HOPE CREEK GENERATING STATION
DOCKET NO. 50-354
DRAFT SAFETY EVALUATION REPORT
OPEN ITEM STATUS

DSER Open Item No. 5 a, b and d (DSER Section 2.4.5)**WAVE IMPACT AND RUNUP ON SERVICE WATER INTAKE STRUCTURE**

DRY AREAS
 WALLS AND SLABS DESIGNED FOR FLOOD LOADS

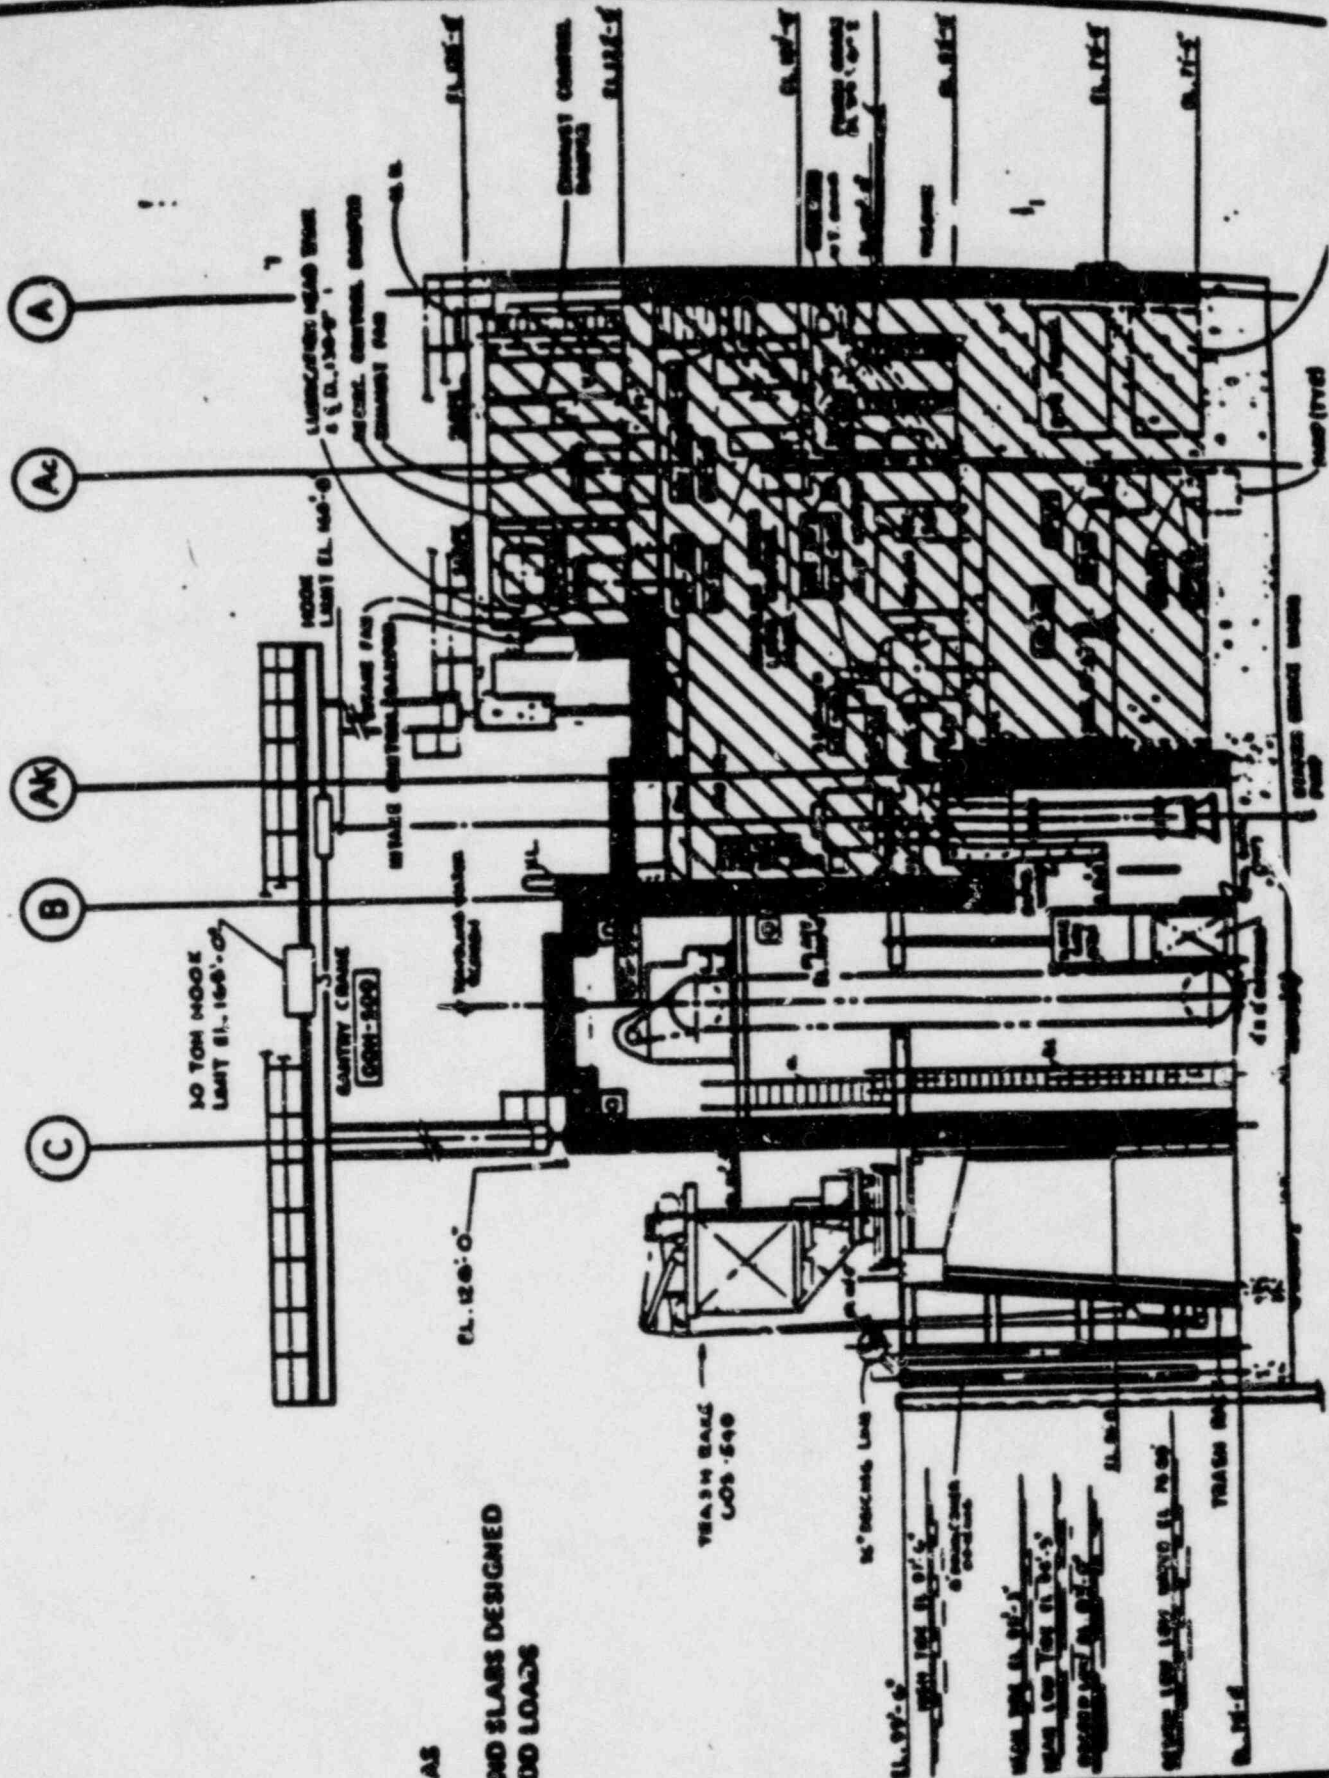
Provide a figure(s) in the FSAR which shows the protection of the station service water system from the flood water (including wave effects) of the design basis flood.

The general arrangement of the intake structure is provided in Figures 1.2-40 and 1.2-41. Section AA of Figure 1.2-41 is reproduced here as Figure 410.69-1 which identifies the watertight areas and the walls and slabs designed to accommodate flood loads. As described in Sections 2.4.2 and 2.4.5, the south and west exterior walls of the intake structure are subject to a maximum wave run-up elevation of 134.4 feet due to the probable maximum hurricane (PMH). Such waves could overtop the roof of the western portion of the structure at elevation 128 feet. However, a rigorous analysis has been performed to determine the depth of water in the low area (elevation 122.0 feet) after wave impact and to confirm that water does not enter the building through the air intake control dampers (bottom elevation 128.5 feet). Therefore, flood water will not enter into the dry area of the intake structure. On the north side of the intake structure, the maximum water level will be only slightly higher than the still water elevation (113.8 feet) during the PMH. According to Table 2.4.6, the maximum wave elevation for the north side of the intake structure is 26.3 feet MSL (elevation 115.3 feet) due to a postulated multiple dam break. Therefore, flood protection of the north exterior wall to elevation 121.0 feet is adequate.

On the east side of the intake structure, the maximum wave run-up elevation due to the PMH equals 121.97 feet. This elevation is due to a 1% wave traveling in the direction of Fetch "A". Fetch A, which is rotated about 15 degrees from Fetch 1 (as shown in Figures 410.69-2 and 410.69-3), is chosen to maximize the wave run-up elevation. Since this elevation is lower than the bottom of the HVAC exhaust opening, flood water will not enter the intake structure from the east side of the building.

In addition the following assessments have been made to confirm the adequacy of the structure and interior components for the overtopping wave:

- a. The exterior walls are designed to withstand the flood loads including the dynamic wave action effects.
- b. The roof hatches at both elevations 122.0 and 128.0 feet have been sealed (caulking, gaskets, etc.) to prevent any intrusion of water. The hatch covers are keyed into

SERVICE WATER INTAKE
 STRUCTURE - FLOOD
 PROTECTION

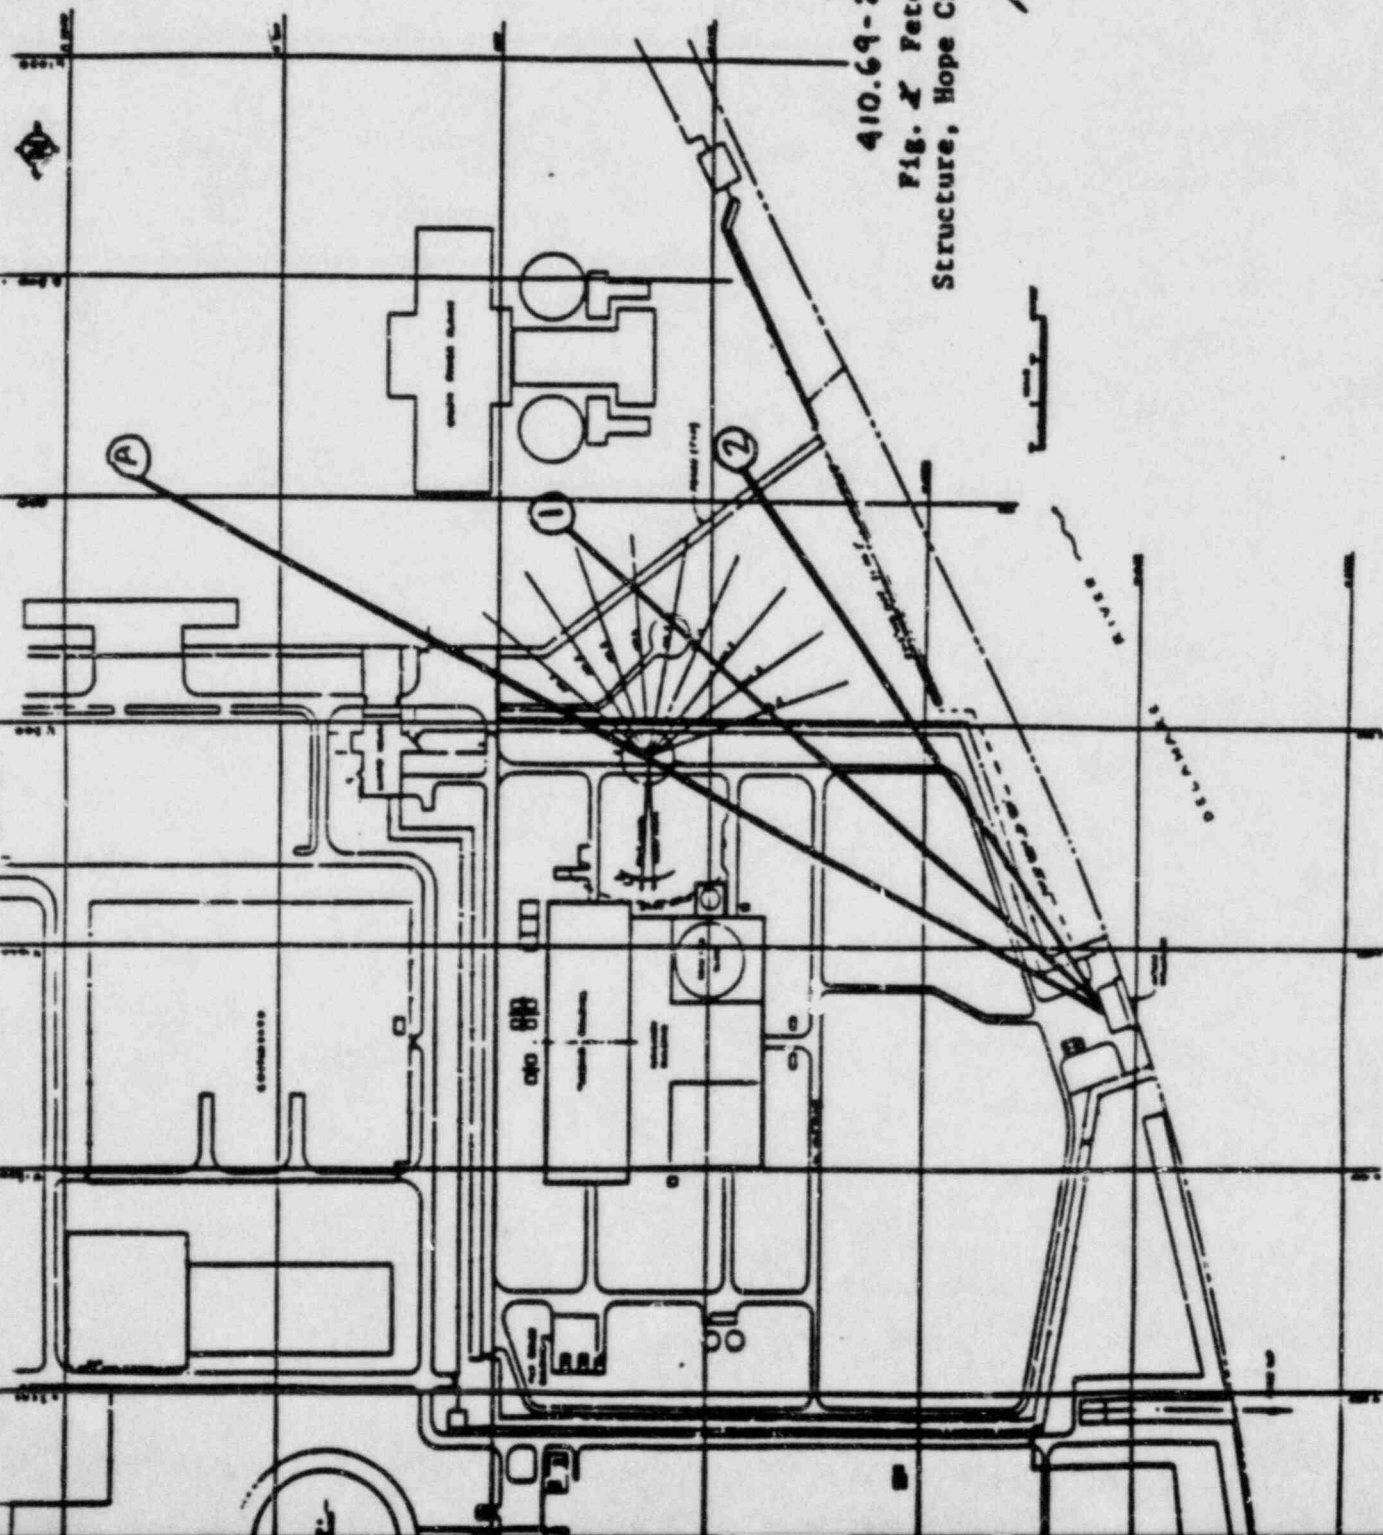
The staff has requested the applicant to provide additional information on the waves that impact on the river face of service water intake structure. The waves impacting on this face of the structure are not reduced in height (depth-limited) as those that traverse plant grade.

1. Analysis of overtopping of Service Water Intake Structure
2. Runup on the East Face of the Service Water Intake Structure

Figure 1

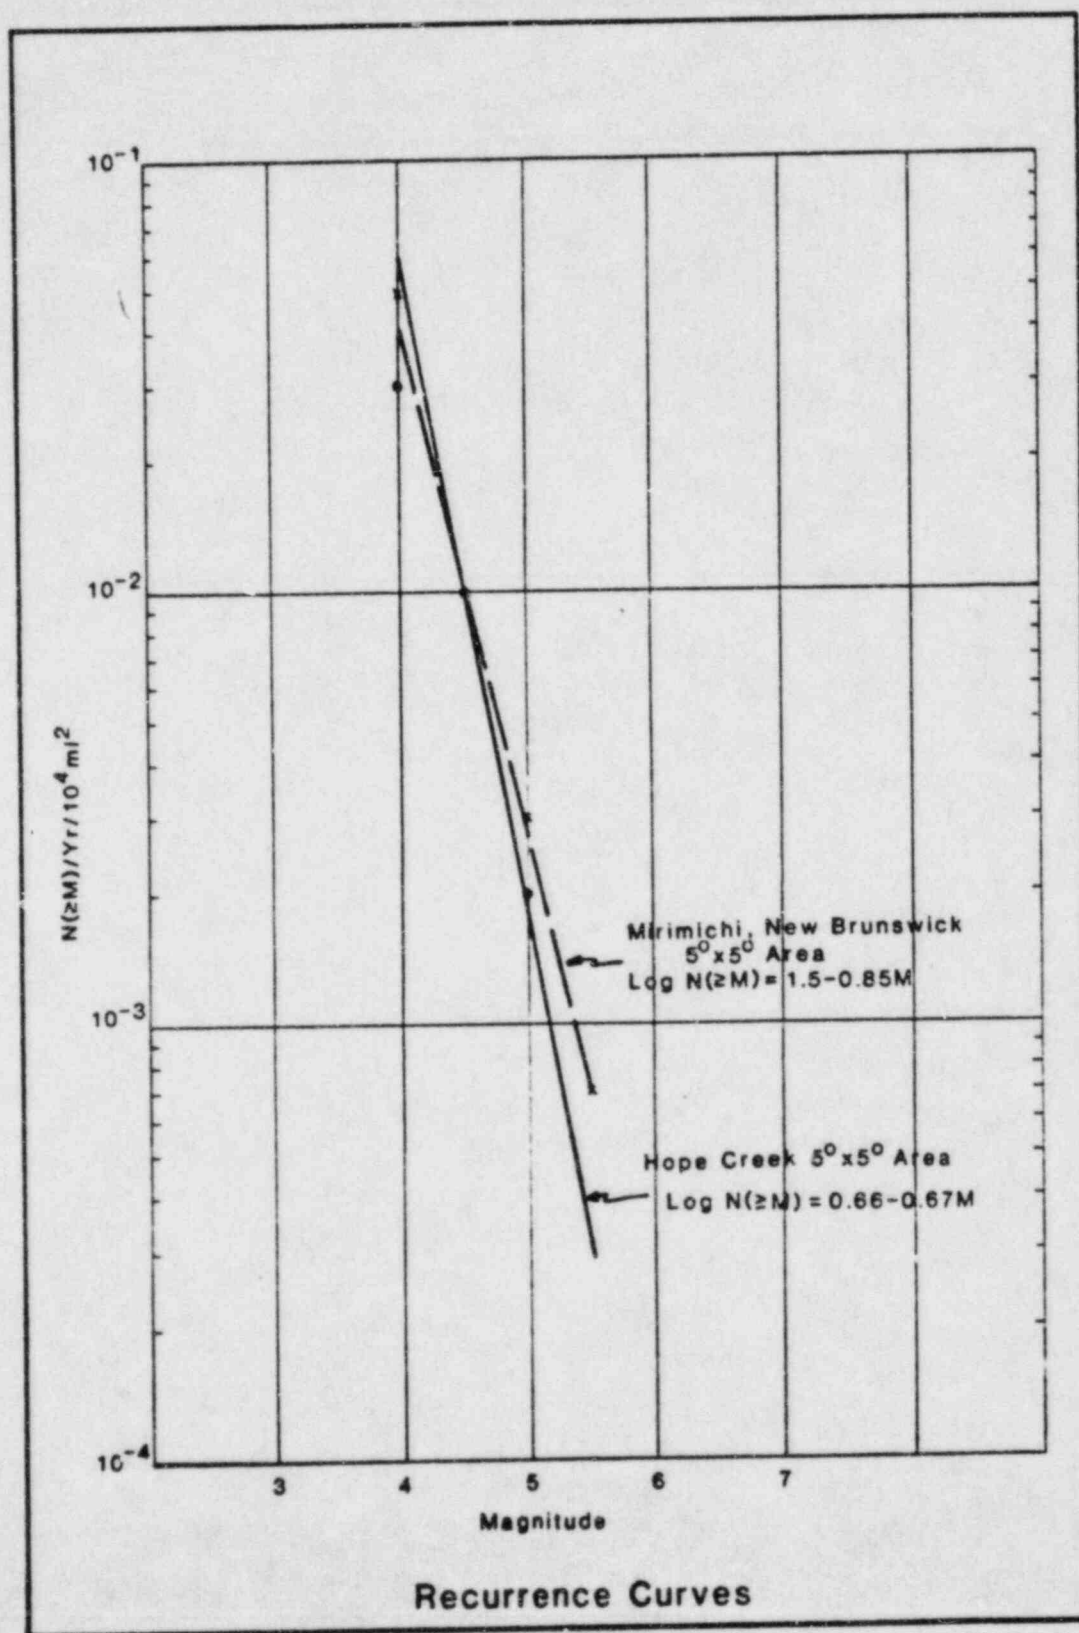
Question 230.8: Question 230.6 addressed the January 9, 1982 magnitude 5-3/4 New Brunswick, Canada earthquake and the effect of the New Brunswick earthquake on the Hope Creek site. The revised FSAR discusses the 1982 New Brunswick earthquake sequence and states "the 1982 Miramichi earthquake sequence was not out of character with the region's previous earthquake history" (FSAR, p. 2.5-80). Is the New Brunswick region more seismically active than the Hope Creek site area? Compare seismic activity rates and recurrence models derived for alternative size regions around both of these areas. (See, for example, the Shearon Harris SER, NUREG-1038 or the Millstone Meeting Summary contained in a February 1, 1984 letter from W. Counsil to B. Youngblood).

A $5^\circ \times 5^\circ$ area surrounding the Hope Creek site and the Miramichi, New Brunswick magnitude 5.7 earthquake epicenter was selected as being broad enough to represent seismicity on a regional level. Events $\geq M_L = 4.0$ were compiled from Table 2.5-1 of the FSAR for Hope Creek and from data files of the Earth Physics Branch, Dominion Observatory, (see Table 1) for the Miramichi region (Adams, 1984, personal communication), not including the January 9, 1982 Miramichi event or its aftershocks. Table 2 provides a summary of the recurrence parameters for both areas and the recurrence curves are shown on Figure 1.
